REMARKS:

Serial Number 10/743,938  
Attorney Docket No. A3-239 US

AMENDMENTS TO THE DRAWINGS:

FIG 9

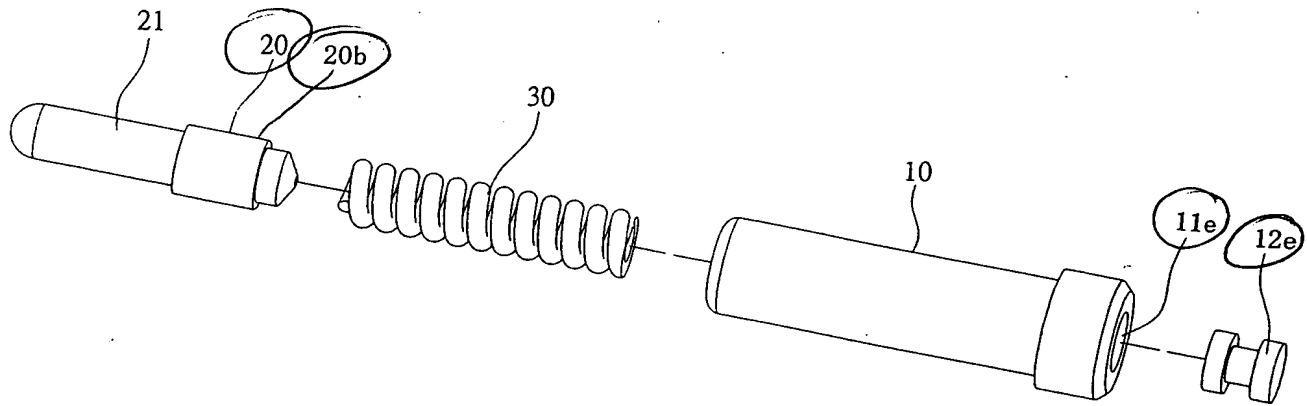
Figure 1 has been modified to show that the pin is in the prior art. Figures 5 - 10 and 12 have been modified by adding additional element numbers to make the drawings more consistent with the specification and claims.

Figure 1 was changed to show that it is in the prior art. Figures 5 - 10 and 12 have been changed with new element numbers to make the drawings consistent with the specification. Attached is a copy of five sheets of drawings which replace the drawings originally filed. Also attached are "Annotated Marked Up Drawings" which show the changes that have been made.
